ZAYO'S PRINEVILLE TO RENO PROJECT

CPUC MINOR PROJECT REFINEMENT FORM

RFI 450

VIEWPORT - 75

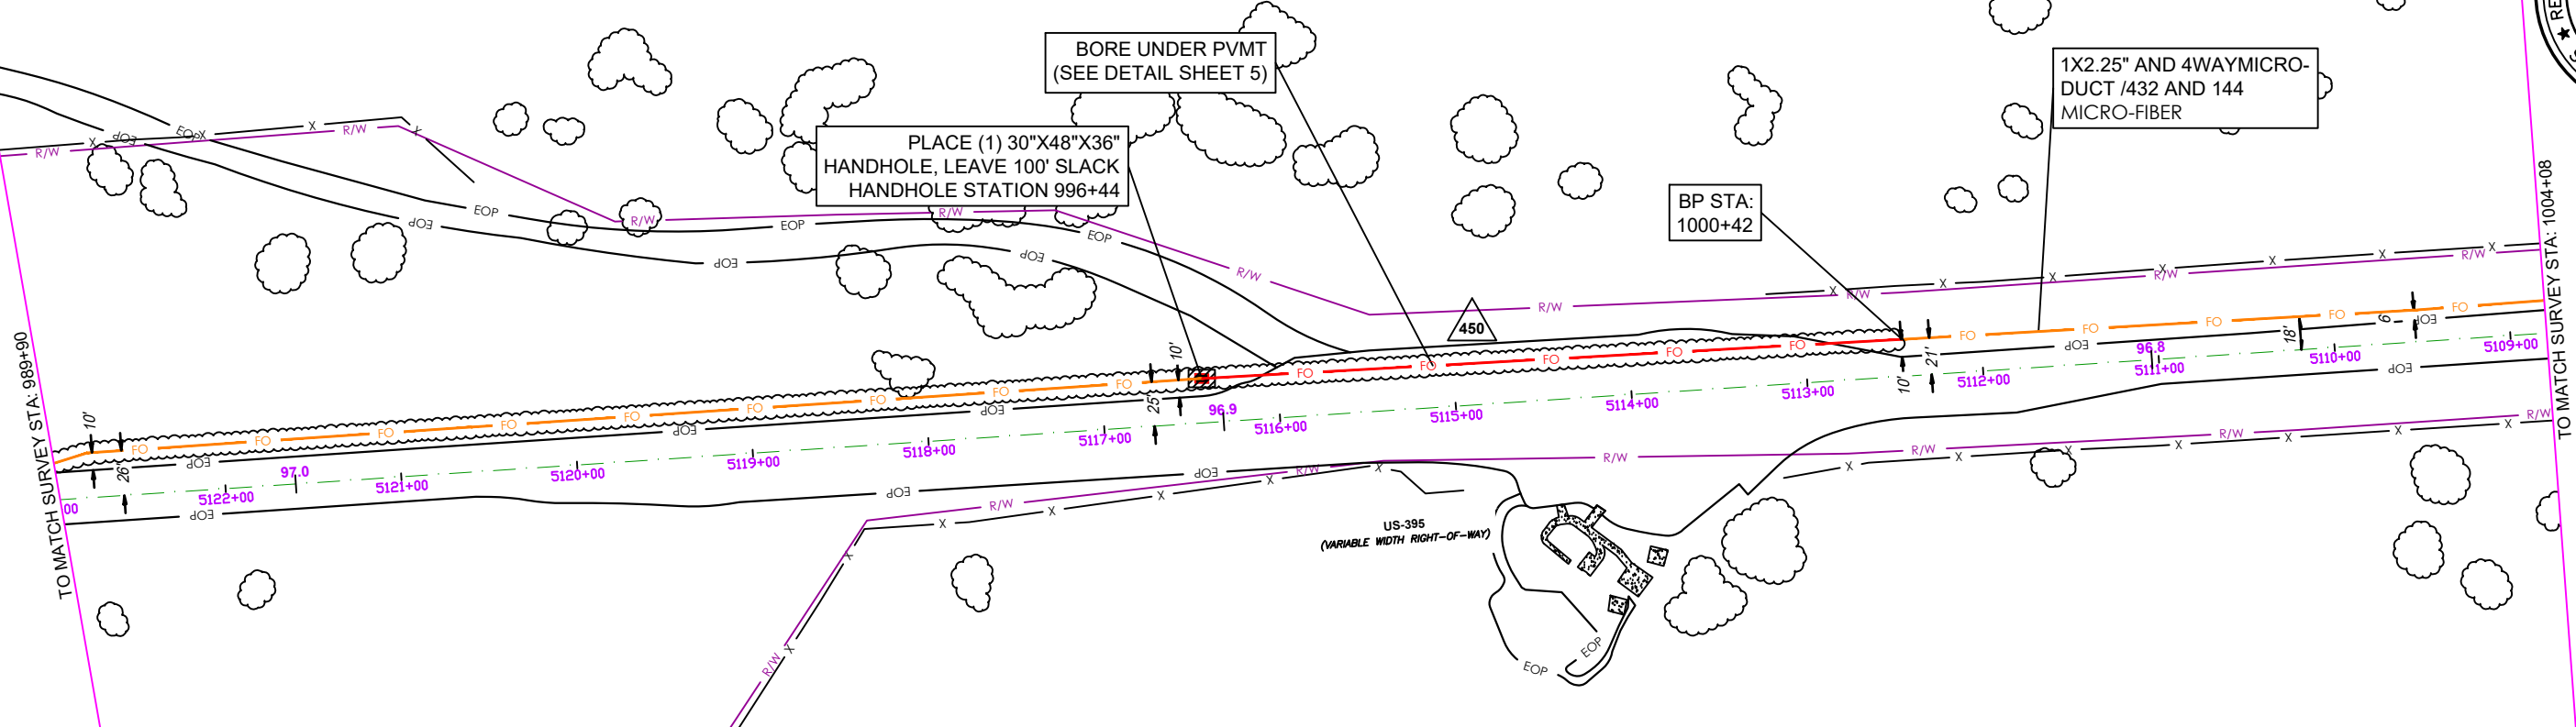
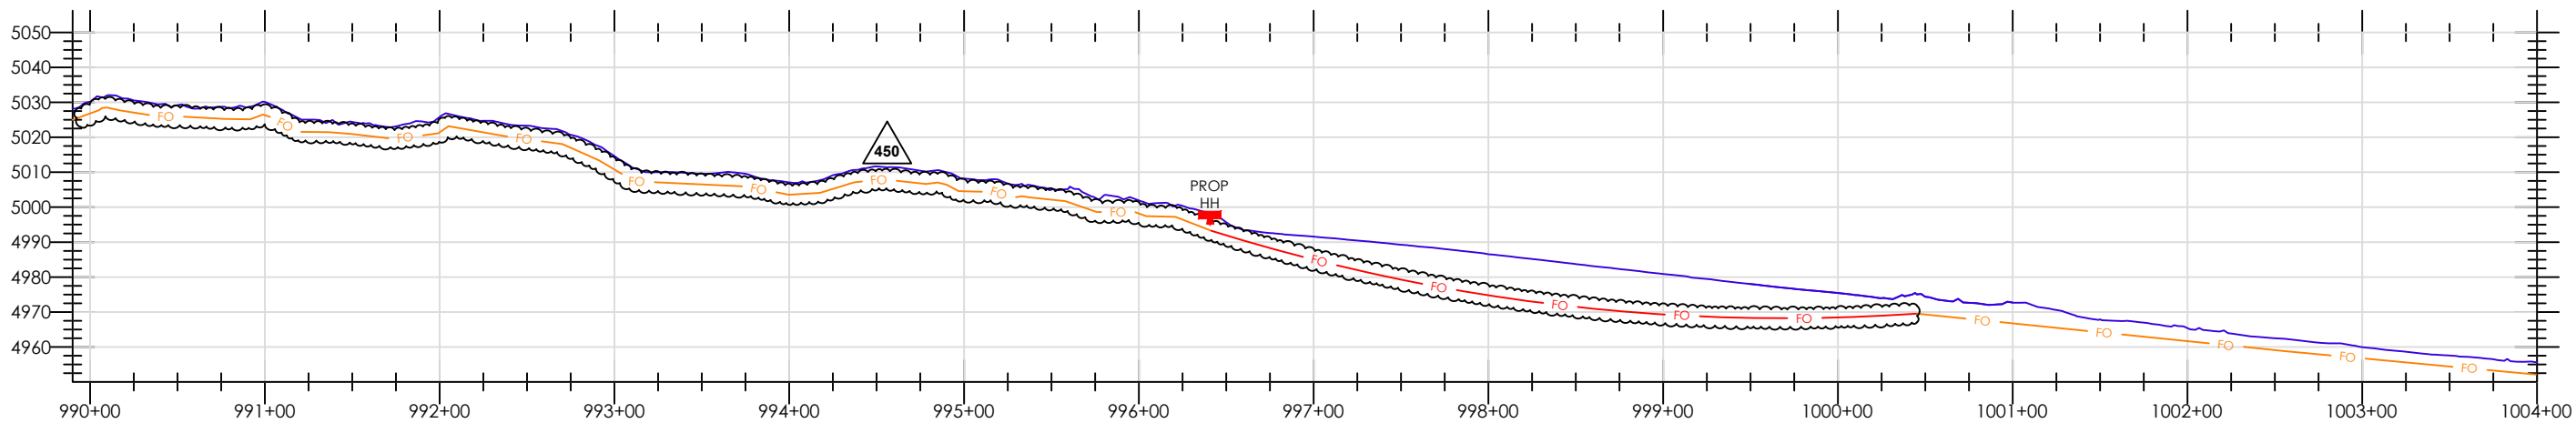
RFI NO. 0450 DEVIATE R/L TO 10' FROM EOP OR TOE OF SLOPE STA 900+04 TO 905+88	12/16/2024
---	------------
